SUNDRY NOTICES AND REPORTS ON WELLS
Do not use this form for proposals to drill or to re-enter an abandoned well. Use form 3160-3 (APD) for such proposals.

Southland Royalty Company
Plug & Abandon Procedure
 September 12, 2017

Well:	Jicarilla 108 #5	API:	3003906394
Location:	1650 FNL & 990 FEL	Field:	Picture Cliffs
Sec, T, R:	Sec. 24, T26N, R5W	Elevation:	GL: 6629'
Cnty/State:	Rio Arriba, NM	By:	Aztec Well Servicing
Lat/Long:	36.47493, -107.3051

Re: Permanent Abandonment
Well: Jicarilla 108 #5

CURRENT WBD

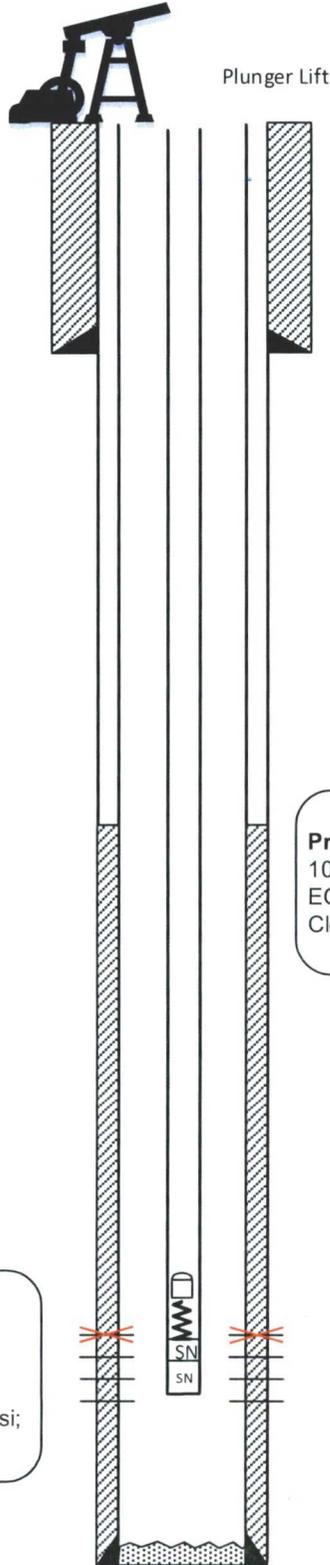
1. Plugging operations authorized are subject to the attached "General Requirements for Permanent Abandonment of Wells on Federal and Indian Lease."
2. Farmington Office is to be notified at least 24 hours before the plugging operations commence (505) 564-7750.
3. The following modifications to your plugging program are to be made:
 - a) Set plug #1 from (2908'-3140') ft to cover Fruitland tops. BLM picks the Fruitland top at 2958 ft.
 - b) Set plug #2 from (2900'- 2549') ft to cover both the Kirtland and Ojo Alamo. BLM picks the top of the Kirtland at 2850' ft and Ojo Alamo at 2599' ft.
 - c) Add plug to cover the Nacimiento top from (1372'-1272') ft. BLM picks the top of Nacimiento at 1322 ft.
